HISTORIC PRESERVATION BOARD

---STAFF REPORT---

CITY OF DELRAY BEACH

Midtown Delray (2017-284): A Class V site plan application for Midtown Delray that includes 39,396 square feet of retail; 11,117 square feet of restaurant; 55,218 square feet of office; 45 dwelling units; and 39 residential-type inn units. The project also includes the relocation of seven of the existing contributing buildings, reconstruction of one existing building, and demolition of two buildings. The relocation of six of the contributing buildings will occur on Block 61 along Swinton Avenue. Another contributing building will be relocated from Block 61 to the Sundy House property.

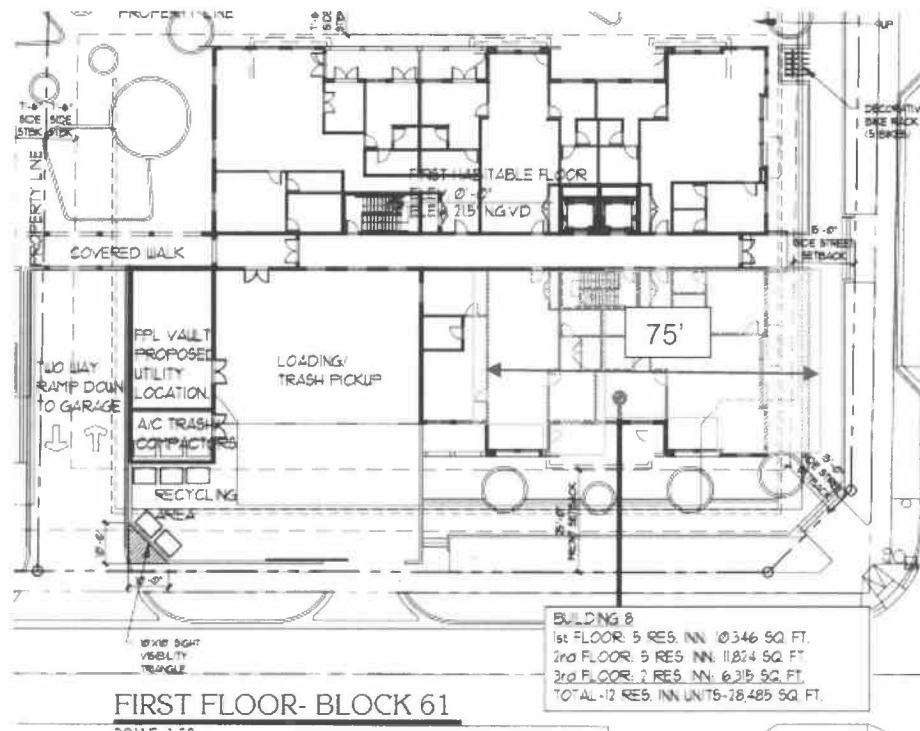
Block 61, Building 8 provides many of the necessary functional aspects of the Midtown Delray Project, which necessitates an additional seventy-six (76) feet in building width along S.W. First Avenue and forty (40) feet along S.W. First Street. Twelve (12) residential inn units comprise Building 8. It also houses a receiving, loading, and air

conditioned and acoustically isolated solid waste area that has direct access to SW 1st Avenue and whose street frontage consumes fifty (50) feet and three (3) inches. A recycling area consumes an additional twenty-one (21) feet and one (1) inch of street frontage. These project logistics have resulted in a façade that is broken up to reduce the continuous length and relieve the visual length the actual dimension suggests. Similarly, the overhead FPL electric lines that run through the center of the property will be reworked to underground facilities, which requires an electrical vault that is shown within Building 8 on Sheet A1.02 of the site plan.

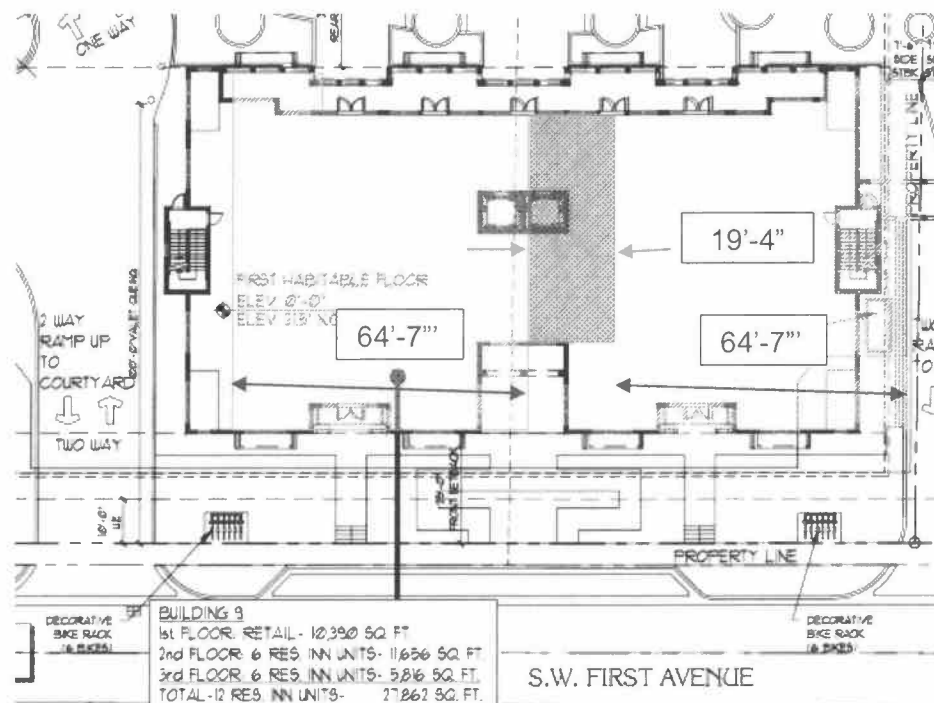
Block 61, Building 9 requires an additional one hundred and four (104) feet in building width in order to provide first floor retail and an additional twelve (12) residential inn units. In order to create a more visual separation in the façade, an additional fifteen (15) foot recess and nearly a twenty (20) foot gap has been added to the middle of Building 9 with landscaping buffers. The main central entry has been eliminated in favor of two entries in the north and south wings. These sixty-five foot wings are connected by the elevator and stairway elements that are stepped back even more on the second and third floors to accommodate upper story planted roofs and a green-wall system. The roof line changes from a sloped roof to a flat roof above the center connection core that further presents the building as two connected facades rather than one long façade.

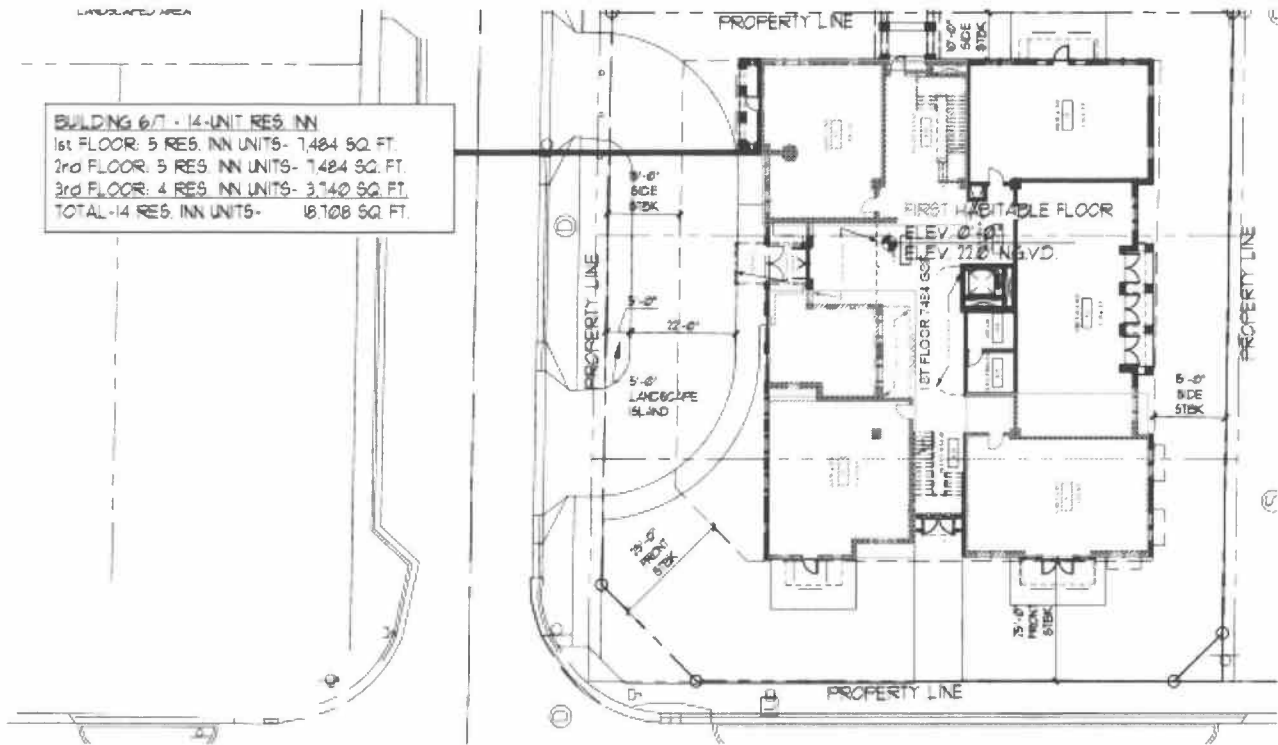
Block 70, Building 6/7 requires an additional forty-four (44) feet and four (4) inches in building width along SE First Street and twenty-one (21) feet and seven (7) inches along South Swinton Avenue in order to accommodate fourteen (14) residential inn units and to integrate the building with the Sundy House. The extension of the overall building beyond the sixty (60) foot façade lengths compensates for the reduction of the permitted three-story building along South Swinton Avenue down to two stories to better transition with the residential along the street and the Sundy House to the west. This is further emphasized with the zoning of the masses separated by the entry facing SE First Street and the stair entry facing South Swinton Avenue.

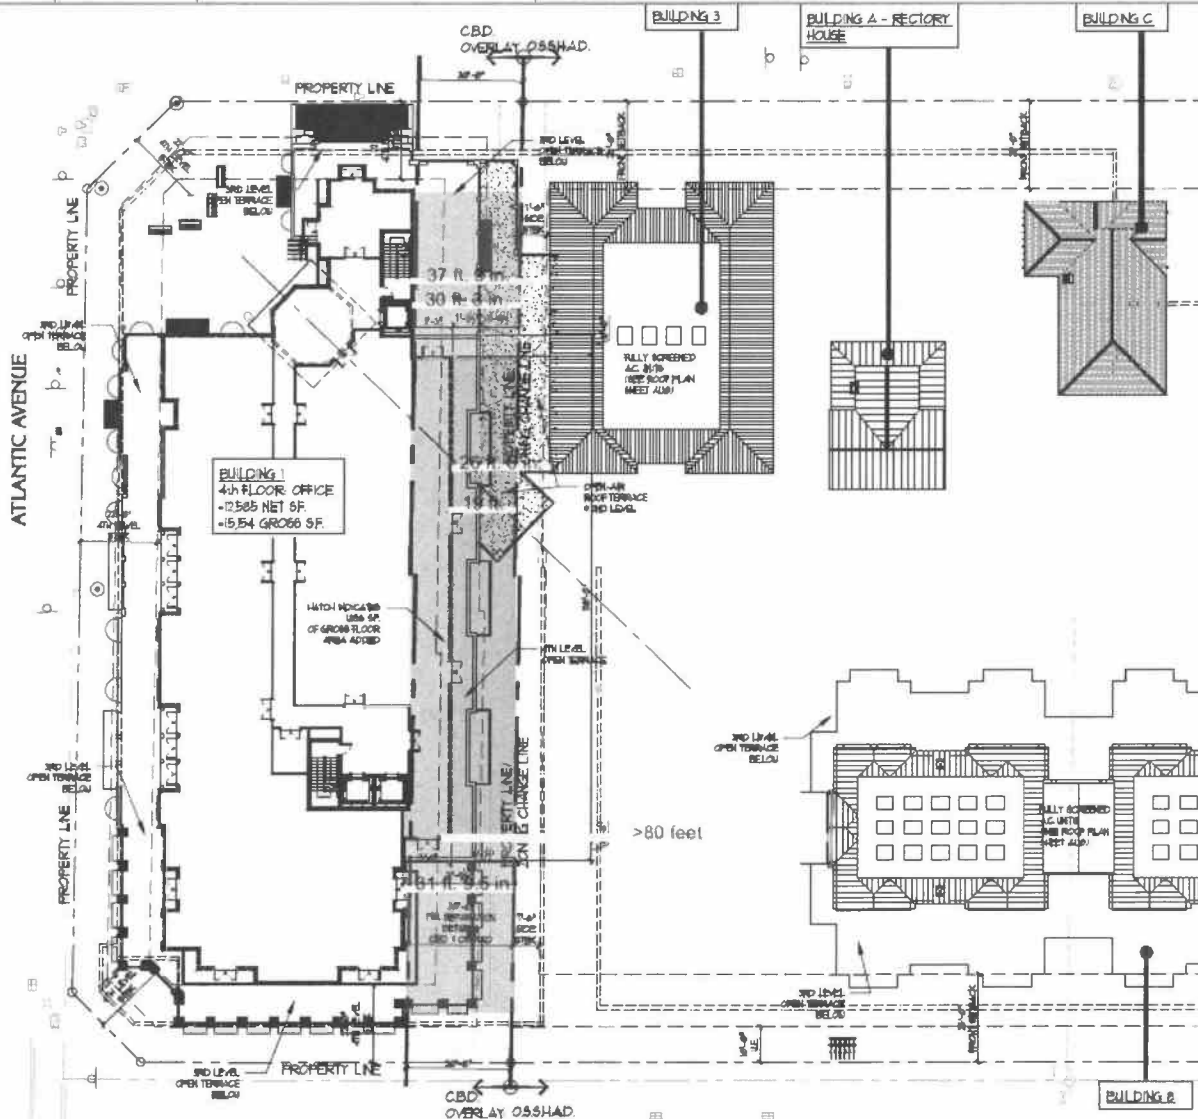
Block	Building	Minimum Setback Required	Rear Proposed Rear Setback
61	1	30 feet	19 feet for a portion of Building 1 from the top of the third floor to the property line only (Approx. 138 feet only) The remainder of Building 1 complies with the 30 foot minimum rear setback.

The intent of this code provision is to create a visual separation between the height differentials of the CBD and OSSHAD zoning districts. The Applicant still meets the intent of the Code despite the proposed waiver request. On the southwest façade of Building 1, there is a significant distance separation (approximately over eighty (80) feet) between Building 1 in CBD and Building 9 in OSSHAD, which achieves the visual separation in excess of the minimum required. On the southeastern portion of the façade, there is a

distance separation (approximately thirty-seven (37) feet and nine (9) inches) between Building 1 in CBD and Building 3 in OSSHAD, which also achieves the visual separation in excess of the minimum required. It is also important to note that the areas of Building 1 that do comply with the minimum rear setback are also the areas that are most visible from the adjacent right-of-ways. Therefore, the maximum amount of visual separation is achieved if the requested waiver is granted. Finally, the requested waiver is the minimum necessary to achieve the best site design and reasonable use of the property while balancing the interests of the community. As such, the Applicant respectfully requests that the waiver be granted because the proposed site design still meets the intent of this code provision.
